UNITED STATES PATENT AND TRADEMARK OFFICE

APPLICATION NO.	FILING DATE	FIRST NAMED INVENTOR	ATTORNEY DOCKET NO.	CONFIRMATION NO.
10/001,547	10/31/2001	Margaret S. Katz	KATZ-1-1001	3677
25315	7590	11/17/2004	EXAMINER	
BLACK LOWE & GRAHAM, PLLC 701 FIFTH AVENUE SUITE 4800 SEATTLE, WA 98104			SCHULTERBRANDT, KOFI A	
			ART UNIT	PAPER NUMBER
			3632

Office Action Summary	Application No.	Applicant(s)
	10/001,547	KATZ, MARGARET S.
	Examiner Kofi A. Schulterbrandt	Art Unit 3632

DETAILED ACTION

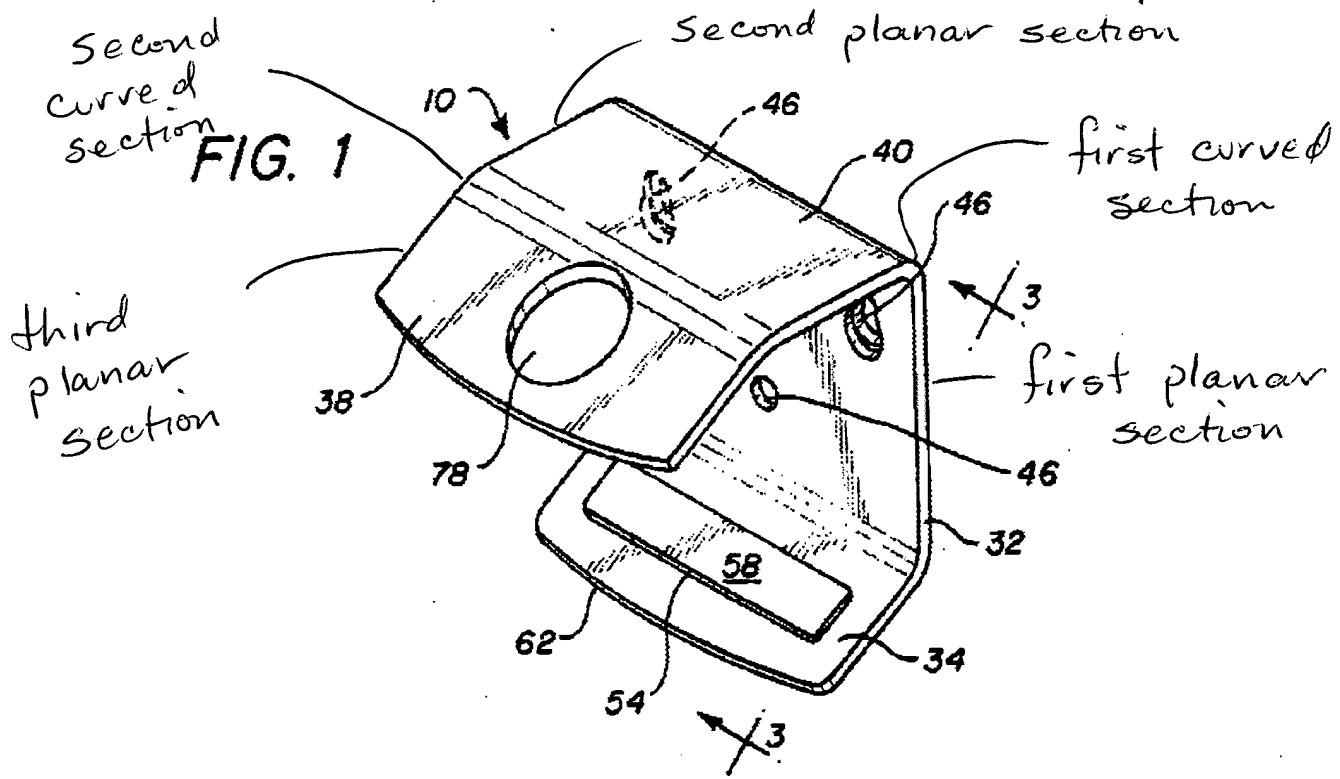
Claims 1-10 are rejected under 35 U.S.C. 102(b) as being anticipated by Perrin et al. (5,758,853). Perrin et al. teach each feature of the claimed invention as shown below. Regarding claim 1, offset means "an abrupt bend in an object by which one part is turned aside out of line" (Merriam Webster's Collegiate Dictionary, 10th ed., Merriam-Webster, Inc., Springfield, Massachusetts, 1999). Each planar portion of Stratton is therefore offset from every other planar portion because none of them are in the same line even though two may be parallel. Regarding claims 2 and 7, Perrin et al. teach mounting screws (48). Regarding claims 3-4 and 8-9, Perrin et al.'s holder can be formed from sheet aluminum or plastic (See col. 4, Ins. 35-40). Regarding claims 5 and 10, no weight has been given to the surface, table or desk (See discussion above).
